Docket Item # 4 & 5
BAR CASE # 2013-00151 &
2013-00152

BAR Meeting
June 5, 2013

ISSUE: Demolition & Alterations

LOCATION: 711 South Alfred Street

Figure 1: 710-720 S. Alfred Street, showing the unbalanced visual effect of a single, painted unit in the red brick row. Google Street View, image date: July 2012.

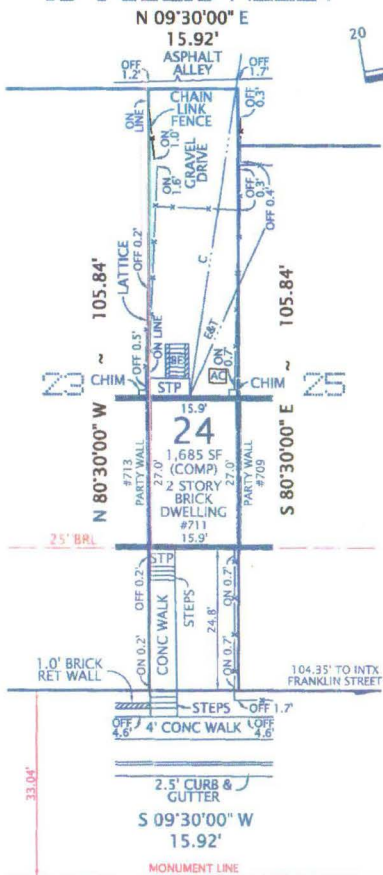
The proposed alterations fall within the Design Guidelines and could be approved administratively, with the exception of the request to paint previously unpainted masonry. Staff does not recommend approval of the request to paint the exterior as it would cause a visual disruption to this block of red brick row houses designed and built as a cohesive block. Instances where the Board has approved painting of previously unpainted masonry were generally for detached, modern houses or on blocks where the buildings are more varied and eclectic in character and material. The majority of brick rowhouses on this block remain unpainted, as it was when constructed, and therefore Staff recommends the preservation of this character defining feature.

- 1) The masonry remain unpainted; and
- 2) The front door be wood.

3 EXISTING REAR ELEVATION
A1 1/4" = 1'-0"

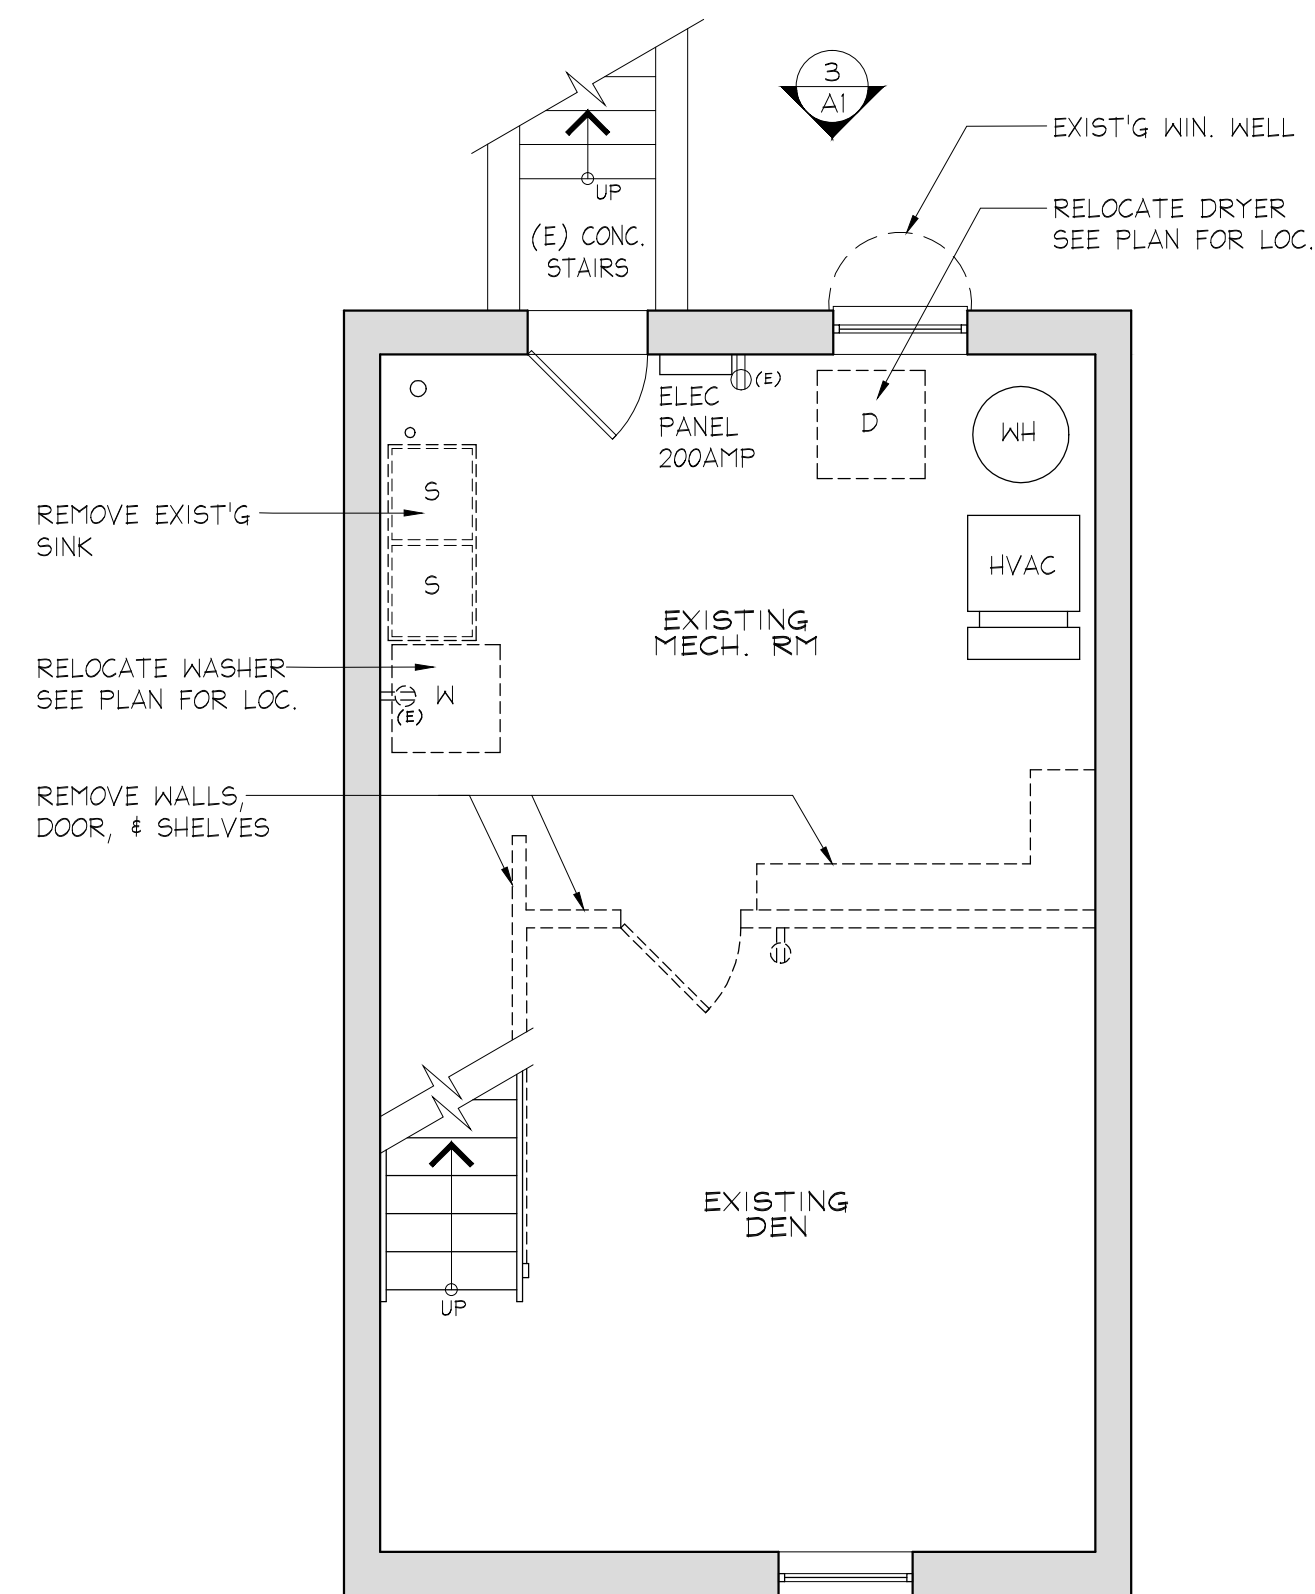
Staff believes none of the above criteria are applicable in this case. The area impacted by the demolition is confined to the rear elevation and is minimally visible from the public right-of-way.
